Access Compliance Report

Public Rights-of-Way

Intersection ID: 26562	Main Street: KIELDON_CT	Cross Street: SETON_HOUSE_LN	Location: N
ADA ID: 165B67D925BC	Ramp Type: PerpDiag	Initial Pass/Fail: Fail	Overall Compliance: No
Severity Score: 33.75			
Codes/Mitigation Info/Possible Solution		Field Measurements/Component Compliance

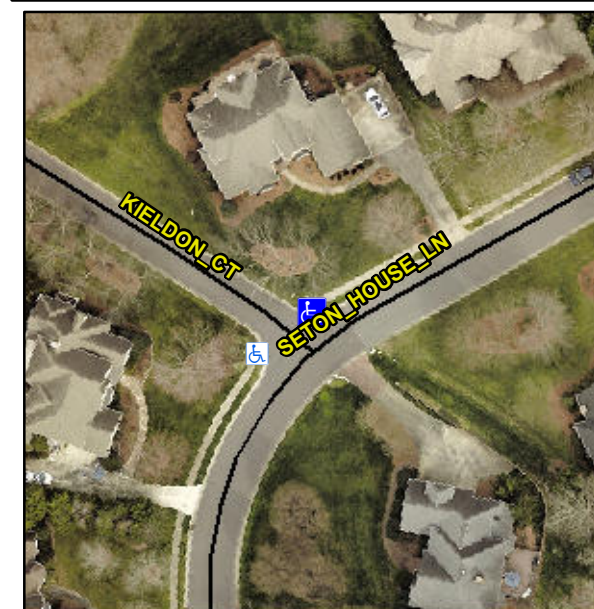
R304.5.1, R304.2.2, R304.5.3

Compliance	Description	Data	Compliance	Description	Data
N/A	Ramp Length (in)	97.0	No	Ramp Slope (%)	10.1
No	Ramp Width (in)	47.0	No	Ramp XSlope (%)	5.4
N/A	Flare Type LT	N/A	N/A	Flare Type RT	N/A
N/A	Flare Slope LT (%)	N/A	N/A	Flare Slope RT (%)	N/A
N/A	Flare Traversable LT?	N/A	N/A	Flare Traversable RT?	N/A
N/A	Landing Length (in)	N/A	N/A	DWS Provided?	N/A
N/A	Landing Width (in)	N/A	N/A	DWS Contrast?	N/A
N/A	Landing Slope (%)	N/A	N/A	DWS Length (in)	N/A
N/A	Landing X Slope (%)	N/A	N/A	DWS Full Width?	N/A
N/A	Landing Curb? (Y/N)	N/A	N/A	DWS Offset (in)	N/A
N/A	Shared Landing?	N/A			
N/A	Gutter Ponding?	N/A	N/A	Gutter Slope (%)	N/A
N/A	Gutter Lip Ht (in)	N/A	N/A	Gutter X Slope (%)	N/A
N/A	Painted X Walk1?	No	N/A	Painted X Walk2?	No
	X Walk 1 Direction	To SW		X Walk 2 Direction	To SE
N/A	X Walk 1 Width (in)	N/A	N/A	X Walk 2 Width (in)	N/A
	X Walk 1 Slope (%)	3.3		X Walk 2 Slope (%)	7.0
	X Walk 1 X Slope (%)	10.6		X Walk 2 X Slope (%)	7.4

Remove & Replace Curb Ramp With Two New Directional Ramps or Equivalent.
